20A CHANGE NOTICE

This is a summary of changes made during production of Multiphase Exciter Model 20A. Some of these changes are applicable to Model 10B and are noted accordingly. This information is presented in accordance with Central Electronics' policy to keep its customers advised of improvements.

3-19-56 Rev.
10B - 20A Change
M139

20 A MIXER CIRCUIT CHANGE

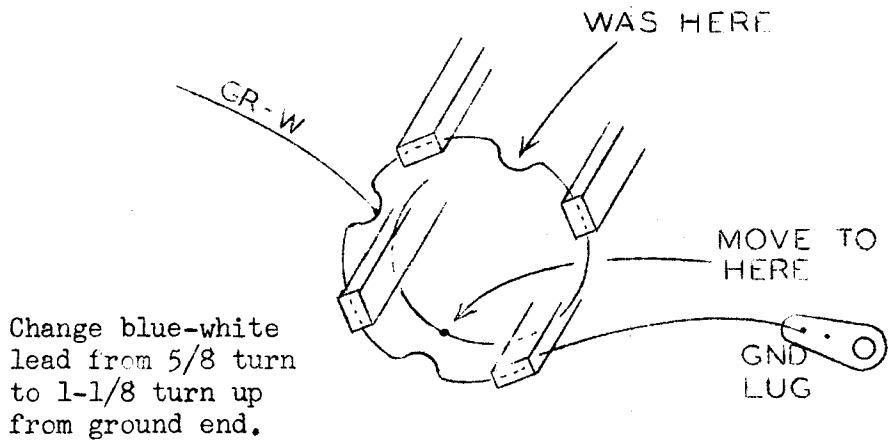
This change places a 10K resistor across the Mixer plate circuit from 160 thru 15 meters. Another 10K resistor is added in series by the bandswitch to make 20K on 10 meters only.

15 METER 6AG7 PLATE COIL CHANGE

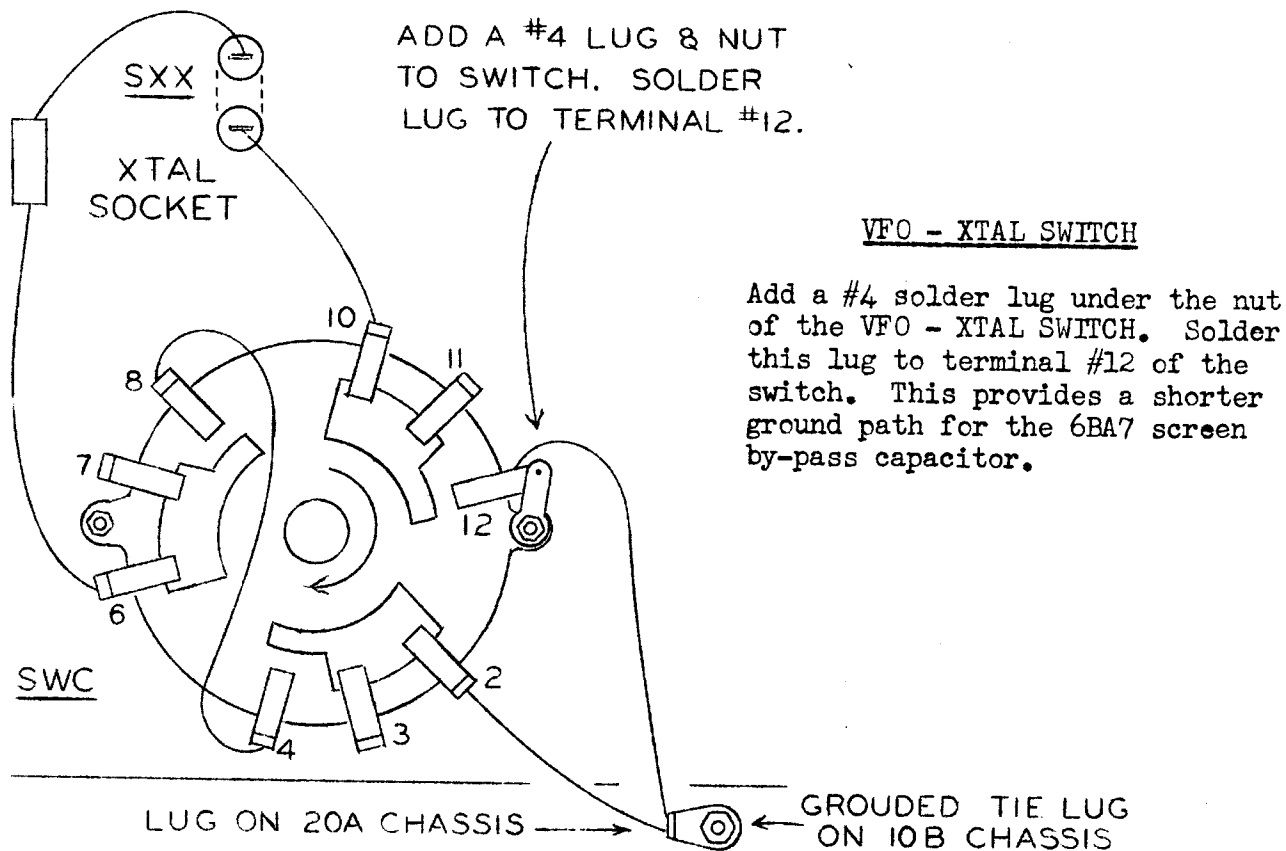
Change blue-white lead from 5/8 turn to 1-1/8 turn up from ground end.

VOICE CONTROL RELAY CIRCUIT CHANGE

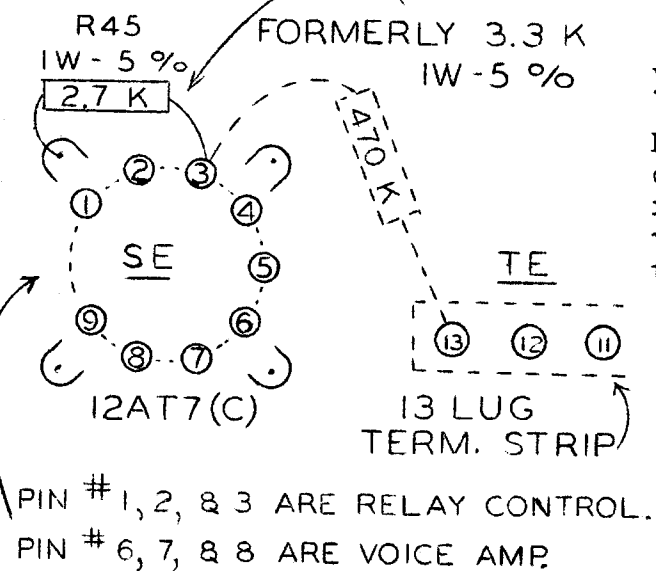
R45, in the cathode of the relay control tube, has been changed from 3.3K 5% to 2.7K 5% in order to lengthen the relay "hold-in" time and sensitivity. If the relay will not release after speaking into the mike, the value of this resistor should be increased.

20-A CHANGE NOTICE

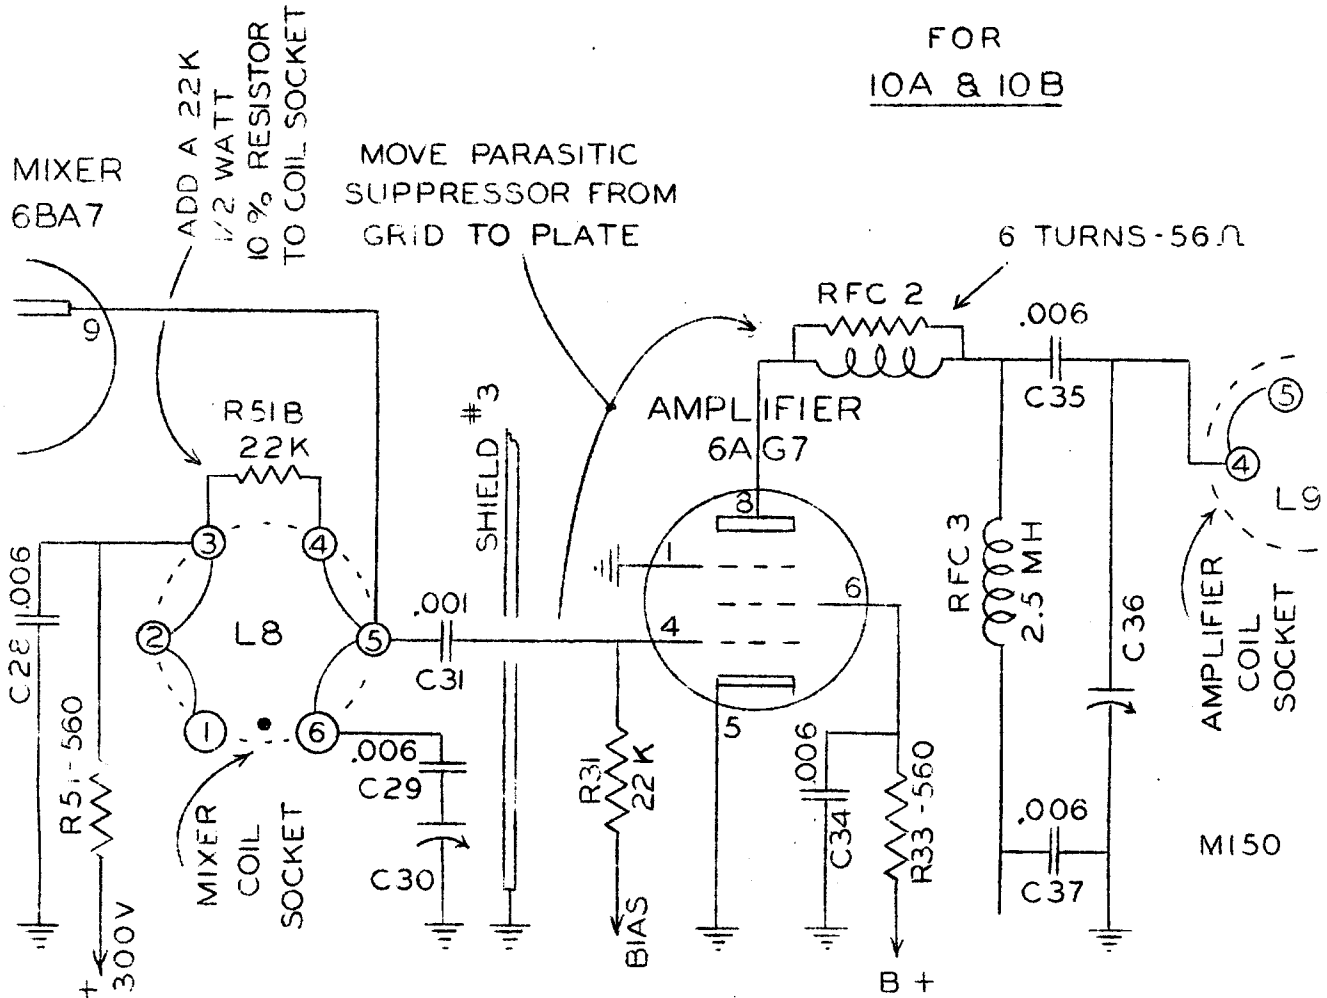
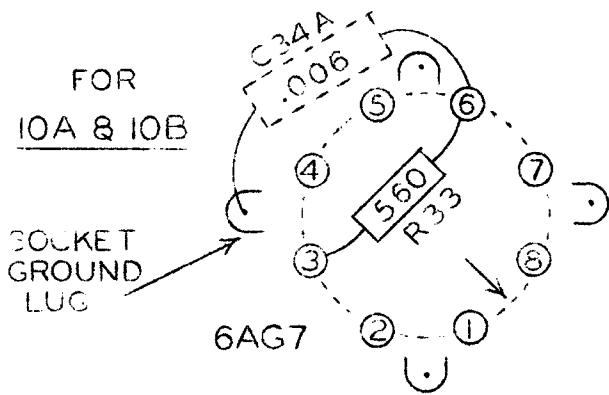
ADD A .006 MICA CAPACITOR FROM PIN No. 6 TO SOCKET GROUND LUG, AS SHOWN. THIS WILL REDUCE THE TENDENCY TOWARD PARASITIC OSCILLATION.

This change raises the 10 and 15 meter output and reduces parasitic tendencies on all bands.
